**MONTGOMERY COUNTY HISTORIC PRESERVATION COMMISSION**  
**STAFF REPORT**

| <b>Address:</b>       | 38 Philadelphia Avenue, Takoma Park  | <b>Meeting Date:</b>  | 12/18/2024    |
| <b>Proposal:</b>      | Fenestration alterations, partial demolition, construction of new rear addition, grading alterations, hardscape alterations. |                       |               |

*Figure 2: Proposed location for the second-story addition, identifying the area of the historic roof to be demolished.*

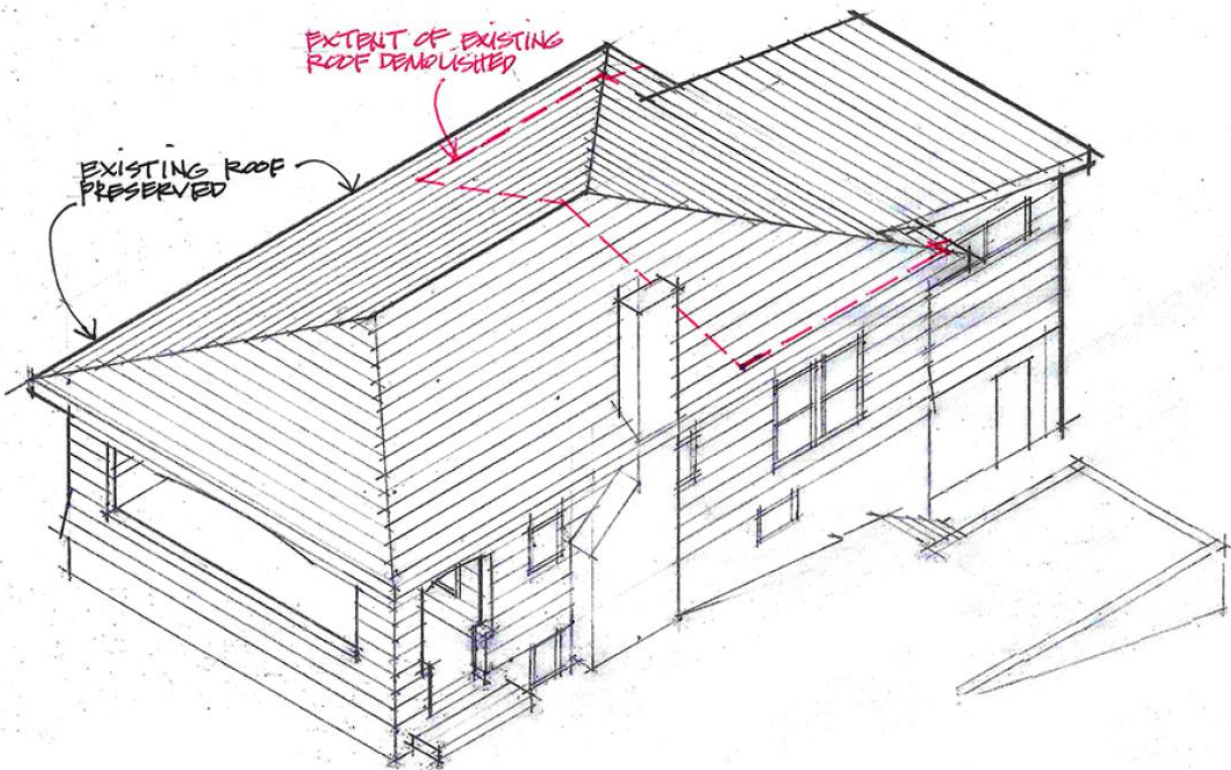
The applicant proposes to remove the rear section of the low-pitched hipped roof (4:12) and install a second story beginning at the third bay toward the rear. The proposal will preserve the front 23’ 10” (twenty-three feet, ten inches) of the historic roof. The proposed hipped roof matches the pitch of the historic hipped roof and has a 23’ 10” (twenty-three feet, ten inches) ridge height. The hipped roof of the rear addition (discussed below) will be 16” (sixteen inches) taller than the intermediate roof. The second-story rear addition extends 6’ 6” (six feet, six inches) to the rear of the historic rear wall plane and will preserve the rear corners and roof overhang.

Staff finds the proposal is consistent with the feedback presented at the Preliminary Consultation and is appropriate under the *Design Guidelines*. In part, Staff finds this proposal is compatible with the

*Figure 3: Proposal presented at the November 11 Preliminary Consultation (left) and revised HAWP design (right).*

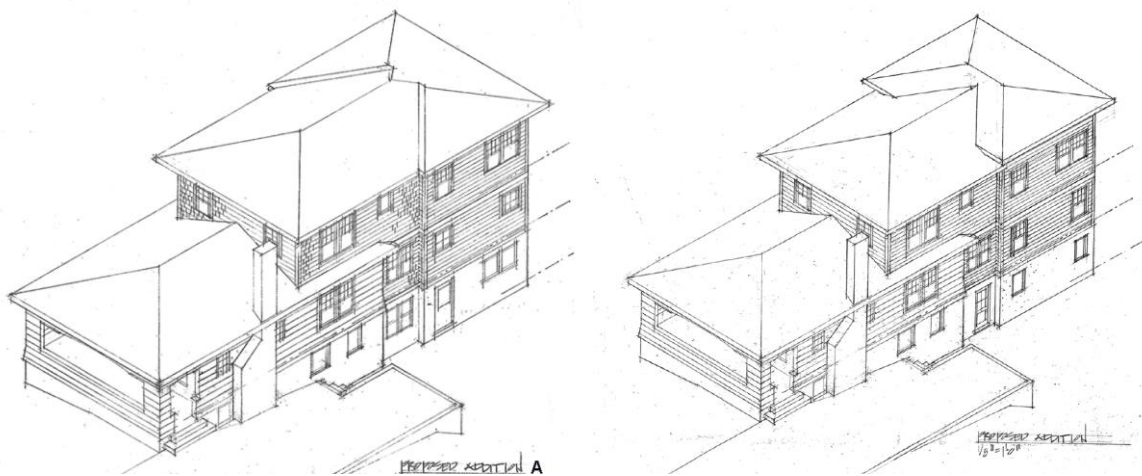
The exterior of the 2<sup>nd</sup> story addition will be covered in 7" (seven-inch) exposure fiber cement shakes. Windows proposed for the addition are aluminum-clad wood multi-light over one sash windows and small multi-light fixed or casements. The applicants' proposal includes two sash windows on the front elevation of the second-story addition.

character of the historic resource because it is 8' 6" (eight feet, six inches) taller than the existing hipped roof ridge and will not overwhelm the size historic house. While this proposal is approximately 2' (two feet) taller than the proposal presented at the first preliminary consultation, the HPC recognized that this proposal is setback from the front wall plane and retains approximately two-thirds of the existing roof.

Staff finds the massing of the proposal similar to the second-story addition approved by the HPC at 7417 Baltimore Ave.<sup>3</sup> Staff and the HPC found that this design is an improvement over that proposal because it preserves the outline of the historic building. The addition constructed at 7417 Baltimore Ave. was designed to be co-planer with the historic wall planes. Additionally, the design failed to preserve the outline of the historic house and did not differentiate the new construction from the historic, as required by *Standard 9*.

PROPOSED REAR ELEVATION  
 3/16" = 1'-0"

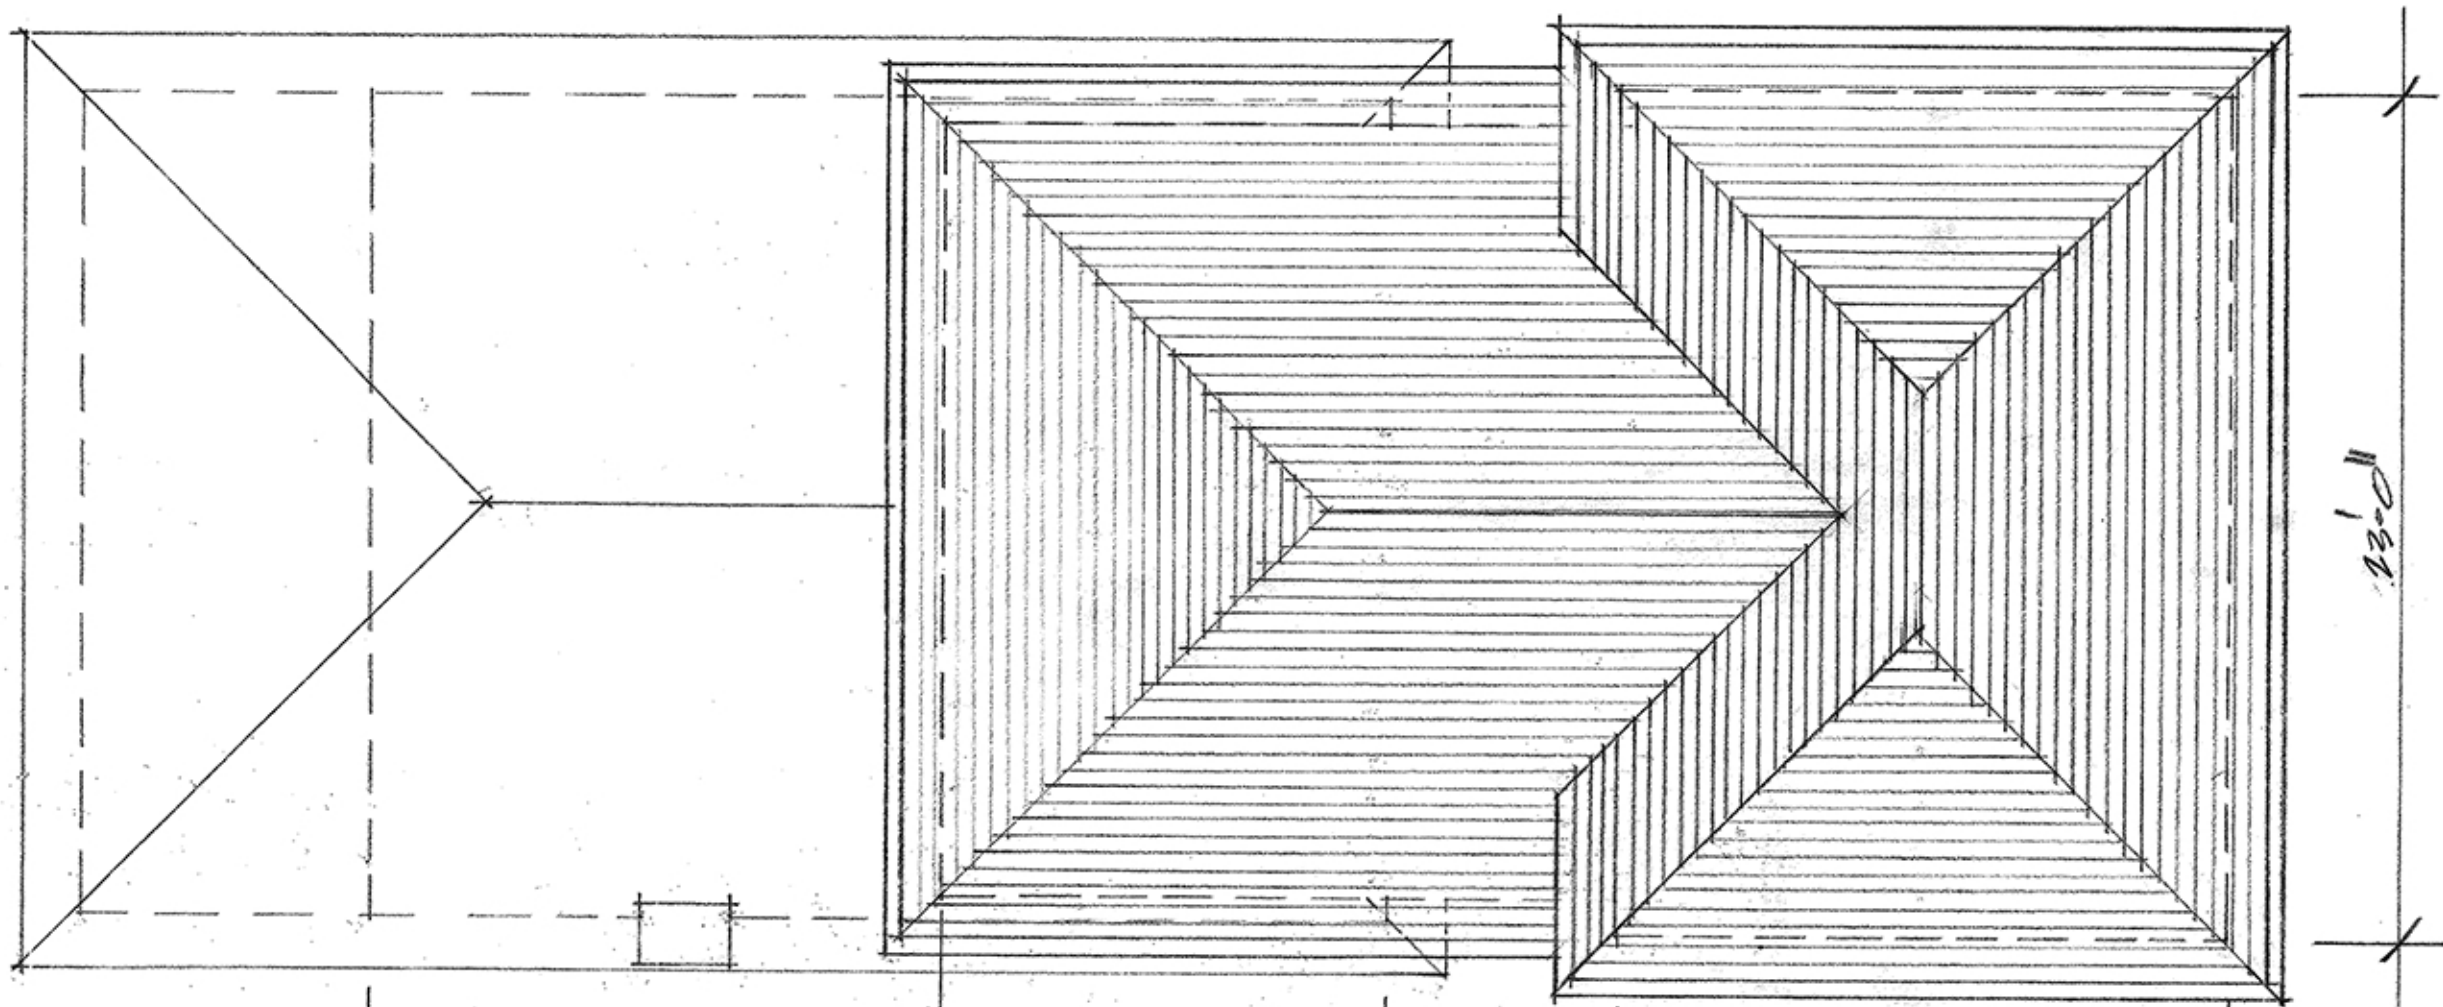
To the rear of the proposed rear addition, the applicant proposes to construct a small deck with stairs down to grade. The proposed decking and stairs will be wood. The drawings do not detail the proposed railing. Staff finds the proposed deck and stairs will not overwhelm the character of the addition and will not be at all visible from the public right of way and, per the *Design Guidelines*, should be approved as a matter of course. Because of the lack of detail, Staff recommends the HPC add a condition to the approval of this HAWP that requires the applicant to submit a compatible railing detail before the HAWP approval documents are released. Final approval authority to ensure the proposed railing is consistent with the requisite guidance can be delegated to Staff. With the recommended condition, Staff finds the proposed deck will be comparable with 24A-8(b)(2) and (d), the *Design Guidelines*, and *Standard 2*.

1. Material and design specifications for the proposed rear deck railing must be submitted to Staff for review and approval before HAWP approval documents are released to the applicant under the Criteria for Issuance in Chapter 24A-8(b)(1), (2), (6), and (d), having found that the proposal will not substantially alter the exterior features of the historic resource and is compatible in character with the district and the purposes of Chapter 24A, with the approved *Guidelines*;
